STATE OF NORTH CAROLINA  
DEPARTMENT OF TRANSPORTATION

Subject: **REVISION to Application for Individual Section 404 Permit and 401 Certification** for the widening of US 321 from SR 1500 (Blackberry Road) to US 221 at Blowing Rock; Watauga and Caldwell Counties; State Project No. 6.739001T; NCDOT Division 11; TIP No. R-2237C, WBS Element No. 34402.2.6

This Application Revision is being submitted to augment the previously submitted application referenced above. This Revision includes responses to comments received in letters from the DWQ and from the USACE, as referenced above, and corrections/clarifications to the original application. This Revision application package consists of the cover letter, attachments for the responses to the USACE comments, a revised EEP acceptance letter, and Revised Permit Drawing Sheets (including revised Wetland Permit Impact Summary sheets) along with the applicable corresponding revised roadway plan sheets.

REVISED 10-5-10  
Permit Drawing  
Sheet 12 of 45

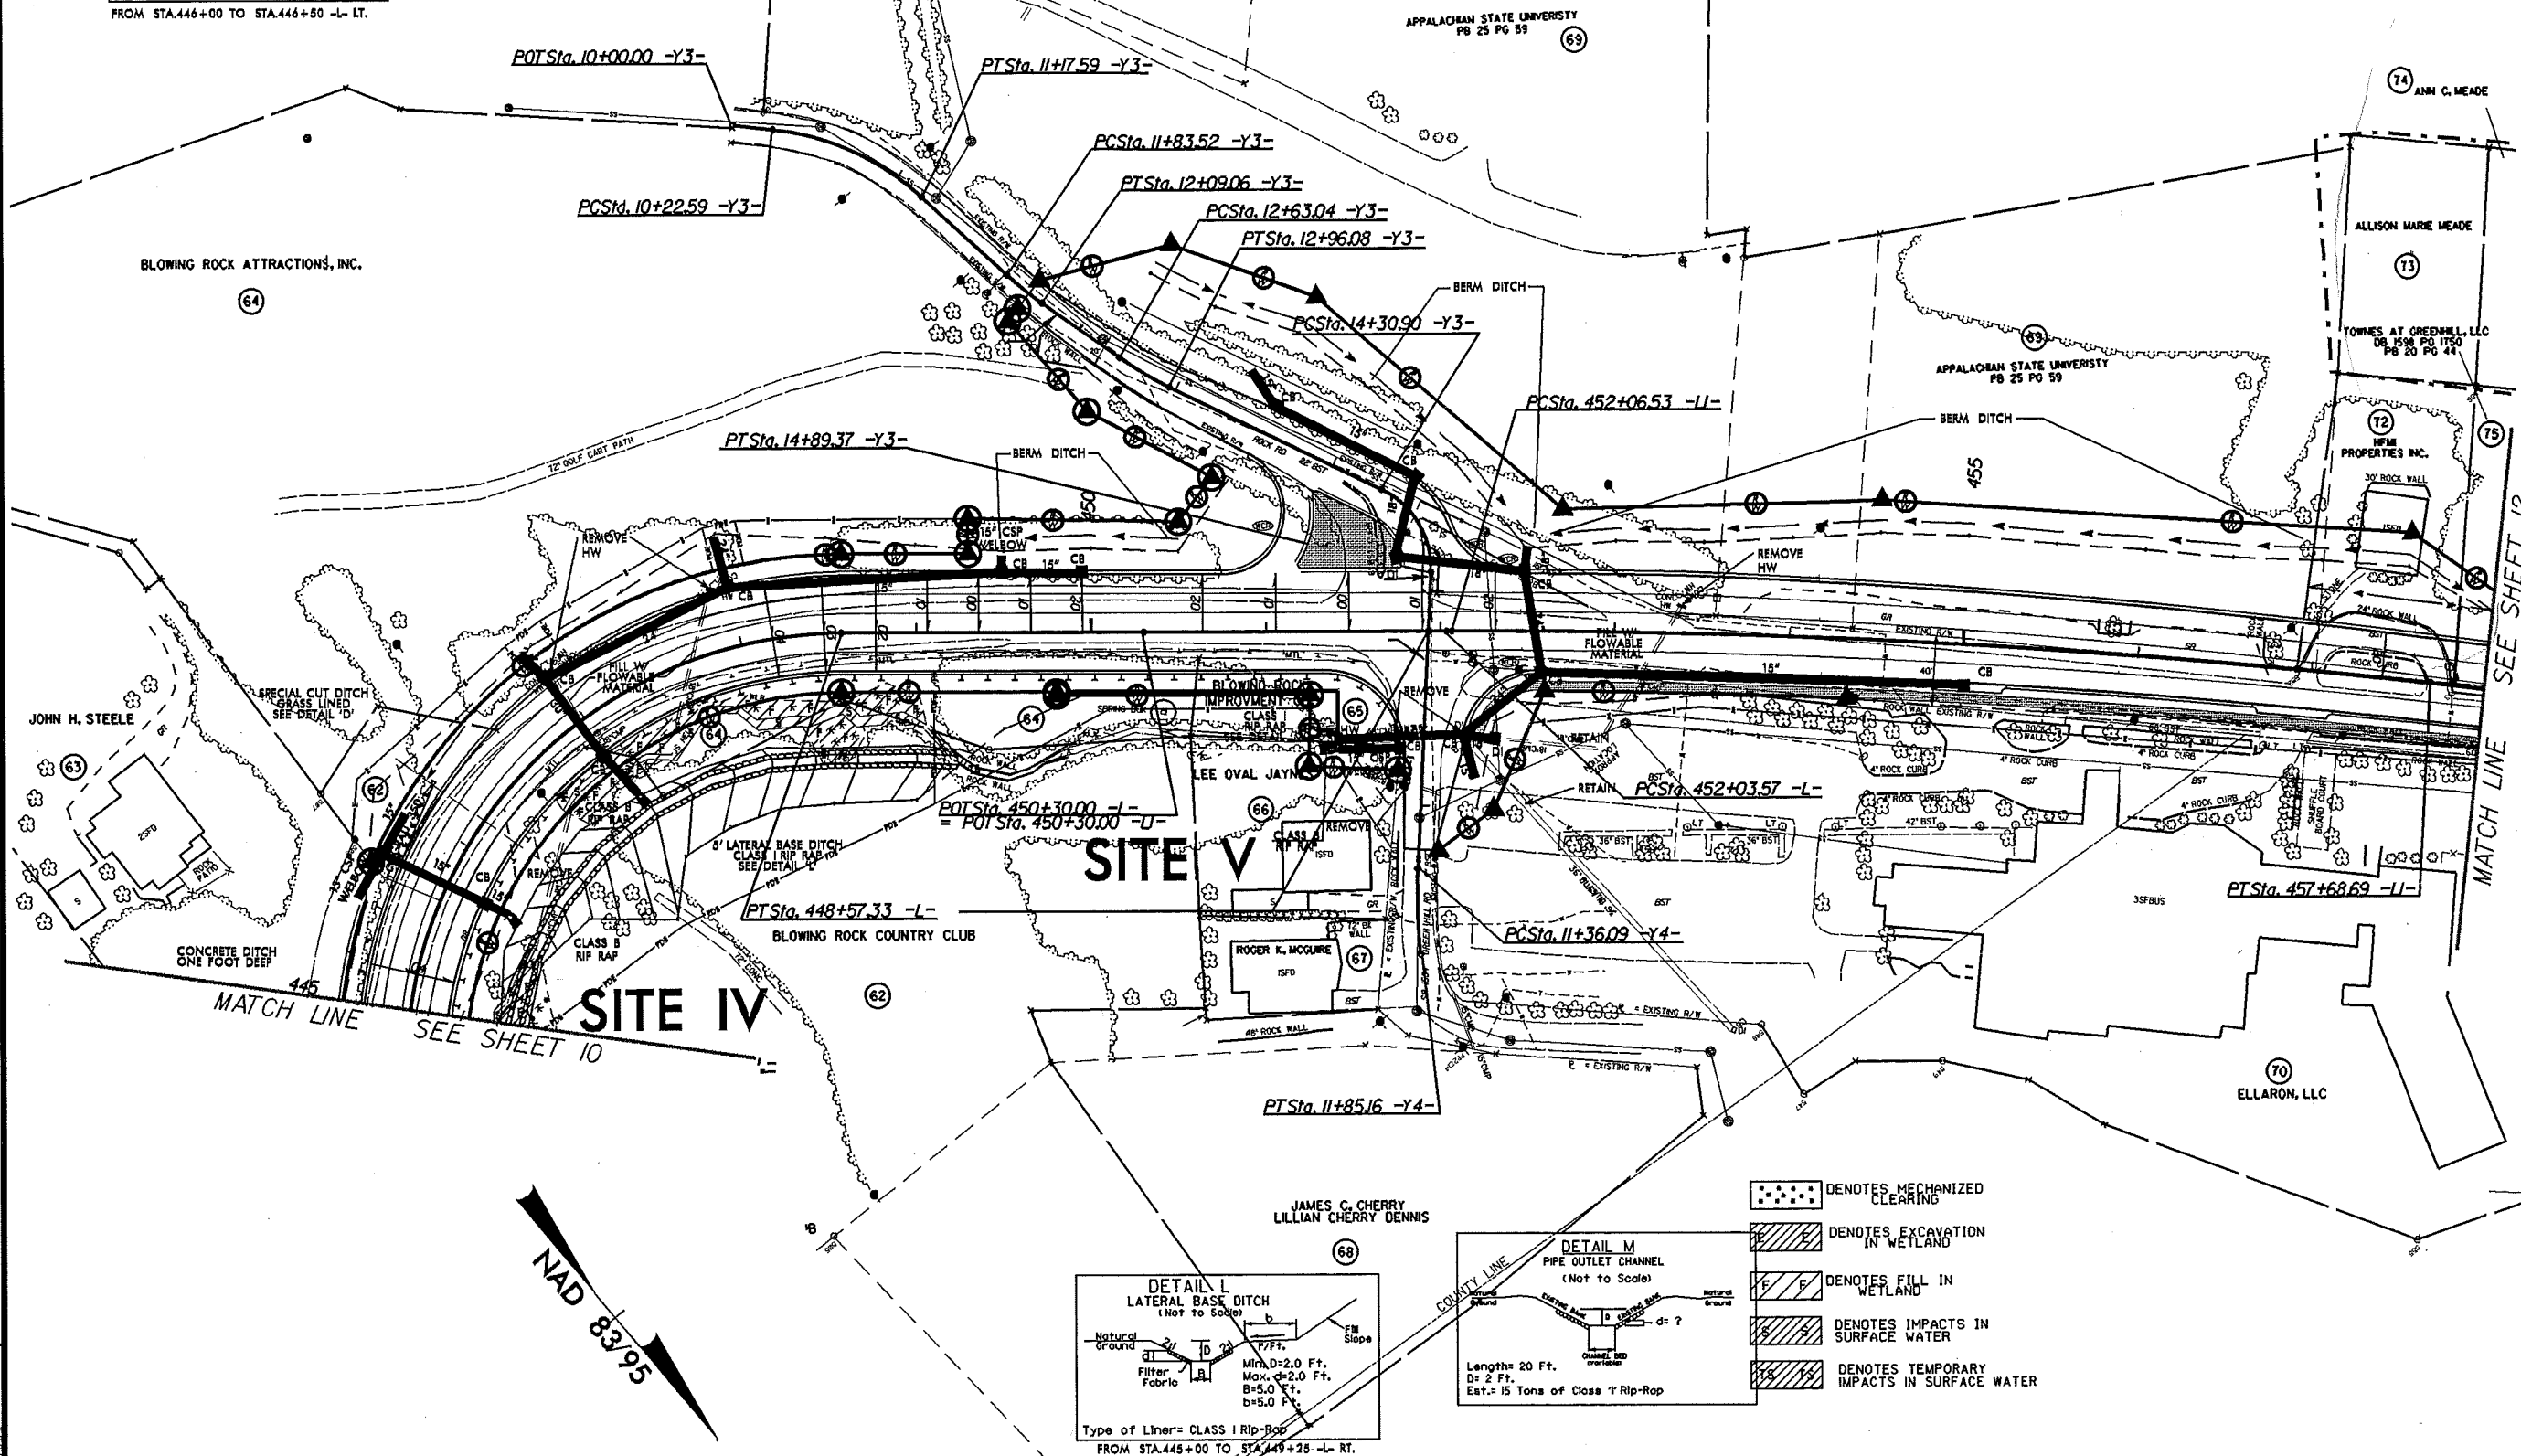
The permit drawings for Site IV have been revised to depict the existing stream connecting directly to the relocated portion of the stream. On the original drawings, there was a disconnect between the two sections of stream. See Revised Permit Drawing Sheets 12-14 of 45 and the applicable corresponding revised roadway plan sheet number 11. There is no change in impacts.

REVISED 10-5-10  
Permit Drawing  
Sheet 24 of 45

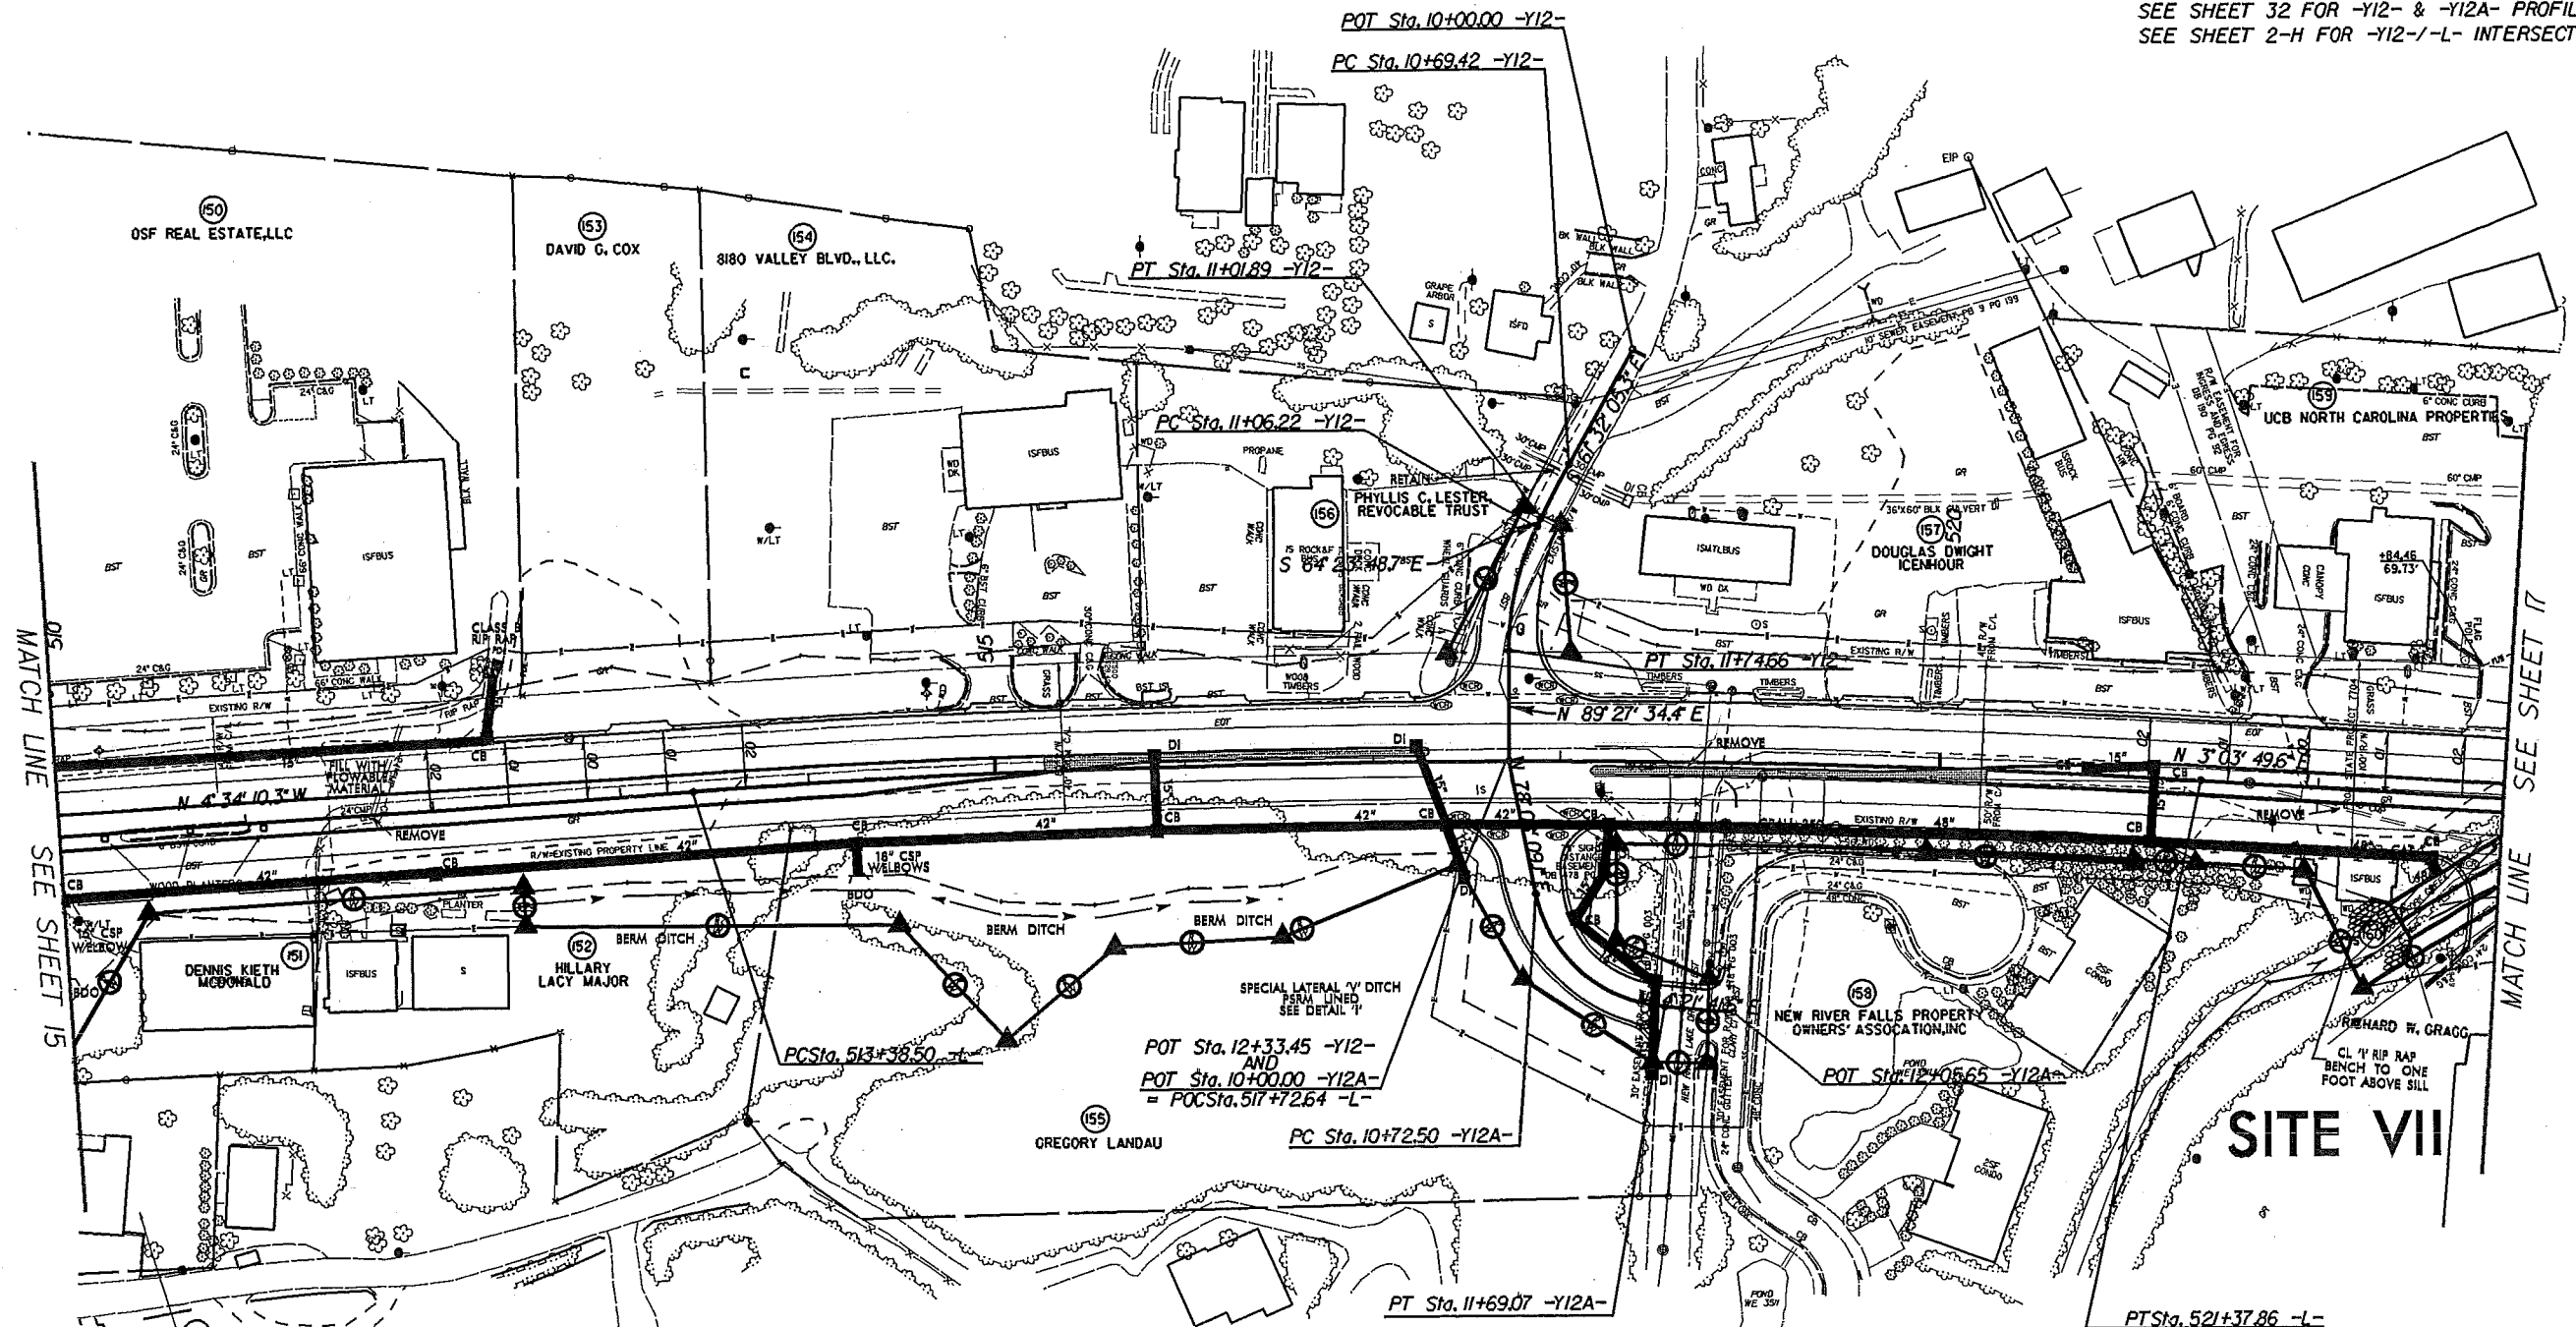
NCDOT has revised the culvert at Site VII. The revision includes the placement of a riprap bench to a height of one foot above the southern sill of the culvert. See Revised Permit Drawing Sheets 24-26 of 45, and 40 of 45, and the applicable corresponding revised roadway plan sheet number 16. There is no change in impacts.

REVISED 10-5-10  
Permit Drawing  
Sheet 31 of 45

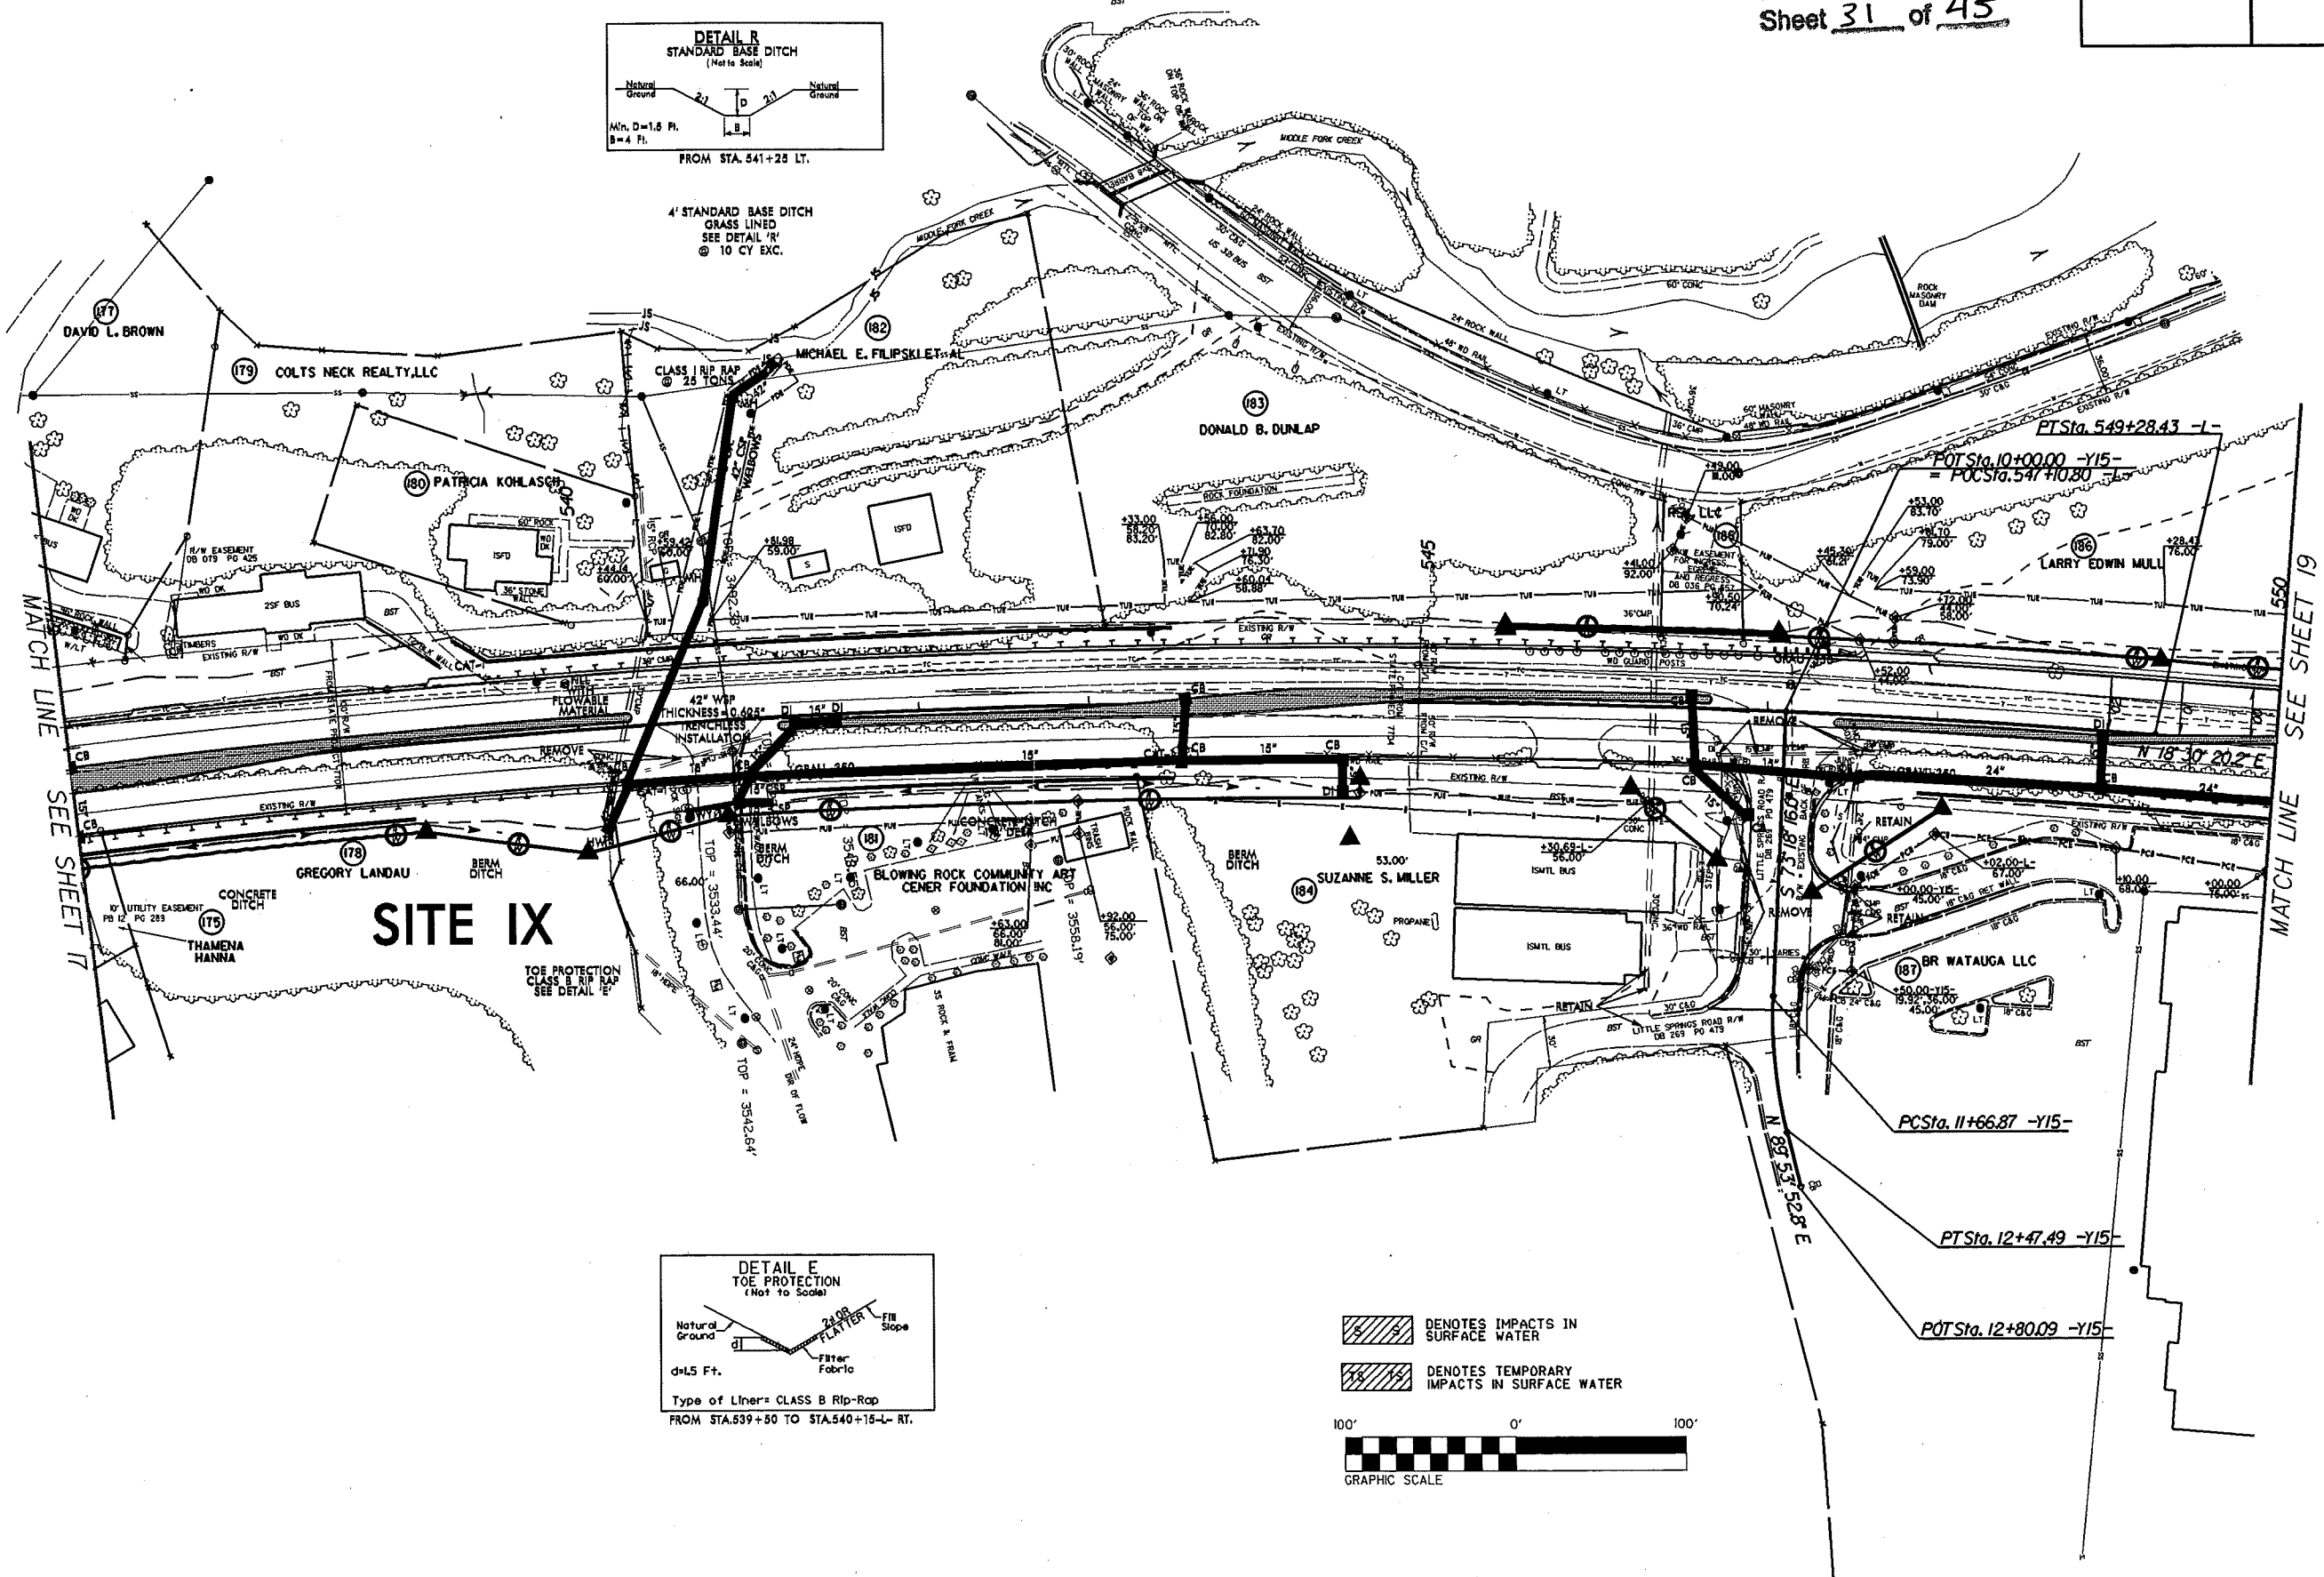
A four-foot base ditch has been included at Site IX to create a direct connection to Middle Fork Creek. The permit drawings for Site IX have been revised accordingly. See Permit Drawings Sheets 31-33 of 45. The connection should be able to be constructed with no additional impacts to the streams.

4' STANDARD BASE DITCH  
GRASS LINED  
SEE DETAIL 'R'  
@ 10 CY EXC.
